ITU - Telecommunication Standardization Sector Temporary Document 09CC-046

Concord, California, 24 – 28 August 2009

TITLE: **G.hn: PHY-Frame Header Extension**

This contribution proposes a generic PHY-frame header extension scheme to incorporate larger than PHY_H bits in the header (Issue 5.0.1.2.1.0.13). It also proposes not to fix the number of header repetitions (*D*) unconditionally for any given medium since the wide range of bandplans shall be accommodated effectively in a single domain (Issue 5.0.1.2.1.2.0.1).

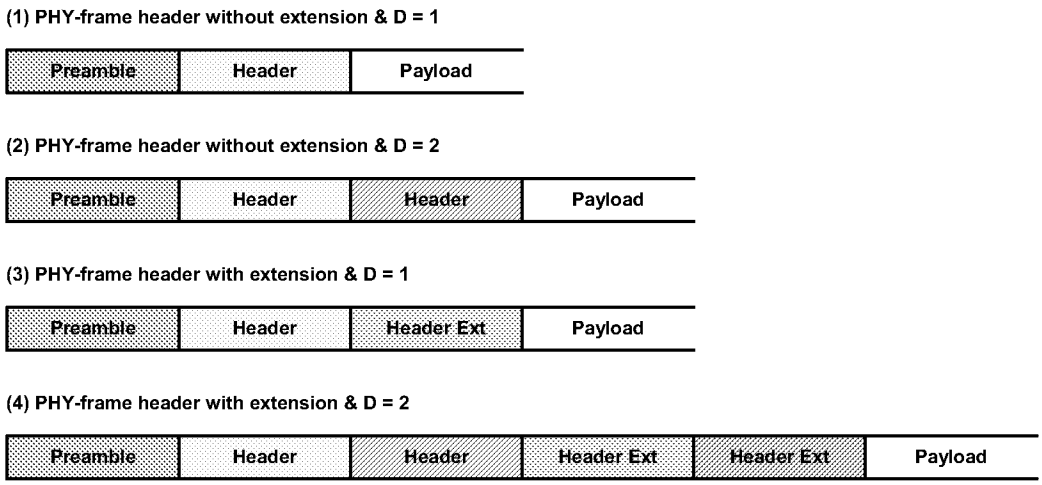
For specifying the number of PHY-frame header repetitions (*D*), we propose not to fix *D* per medium, rather to define a technique to use different values of *D*. Although it is understood that more repetitions may be necessary in coax, fixing *D* unconditionally for any given medium is neither a flexible nor an efficient solution because

- ❑ Even in the power line medium we may face the similar situation as narrower bandplans are added to support SmartGrid applications (Issue 1.90.10.1). In this case we need a flexible scheme to support narrow and wide bandplans at the same time.

- ❑ Applying $D = 2$ uniformly for all bandplans in coax makes G.hn less efficient for wide bandplans (e.g., 200MHz-CRF) as well as over the legacy system.

The possible cases of PHY-frame header transmissions are shown in the following figure.
